Planning Application No. A/NE-KTS/517

Proposed Temporary Warehouse (excluding Dangerous Goods Godown) with Ancillary Office for a Period of 3 Years within "Recreation" Zone. Lots 2219 (Part) and 2220 (Part) in D.D. 92, Kwu Tung South, Sheung Shui, New Territories

> Compliance with Approval Condition (h) the submission of a drainage proposal

Compliance with Approval Condition (c) the design and provision of vehicular access, parking and loading/unloading spaces and pedestrian facilities

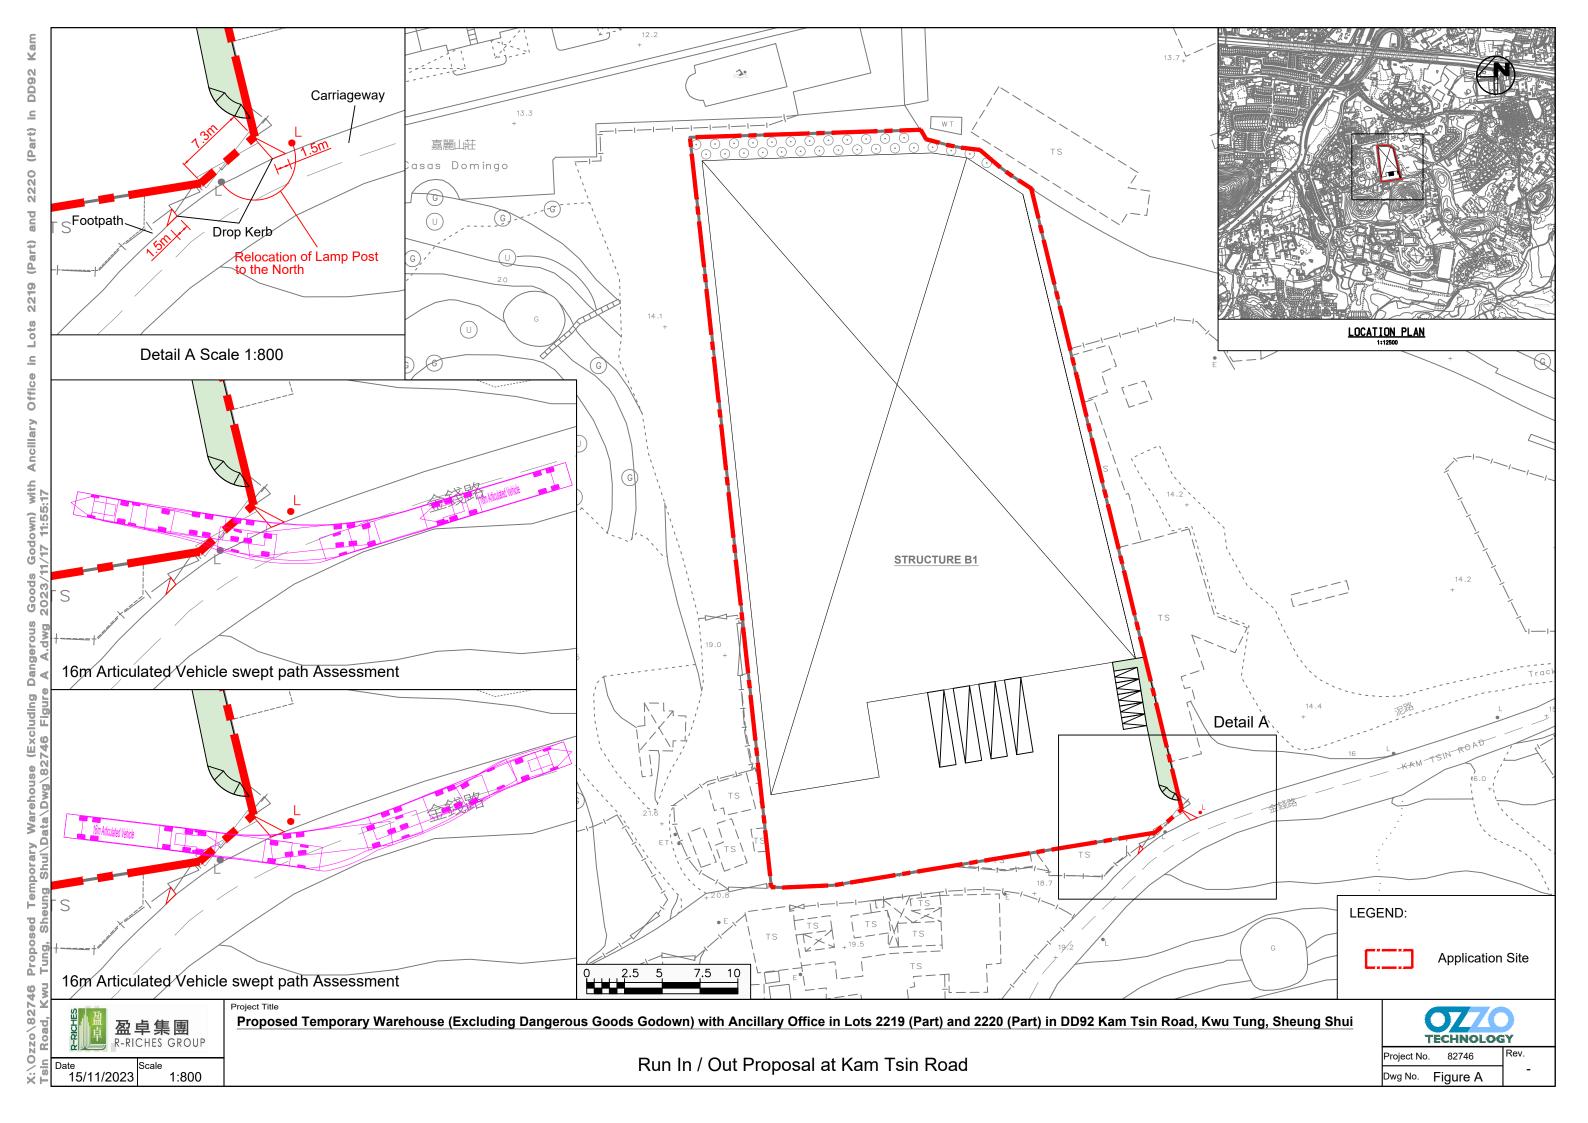
Approval condition (e) has been partially complied with, subject to the following condition imposed by the Highways Department (HyD). The applicant shall submit a further proposal to HyD's office detailing the proposed permanent relocation works. Upon receiving the proposal, HyD's term contractor will provide the corresponding lighting improvement scheme and his office will advise the applicant of the cost of the works that to be settled by the applicant in form of Demand Note. Besides, the applicant shall be responsible for all the civil works, i.e. public lighting cable ducts and drawpits, relating to the permanent relocation of the concerned lamppost.
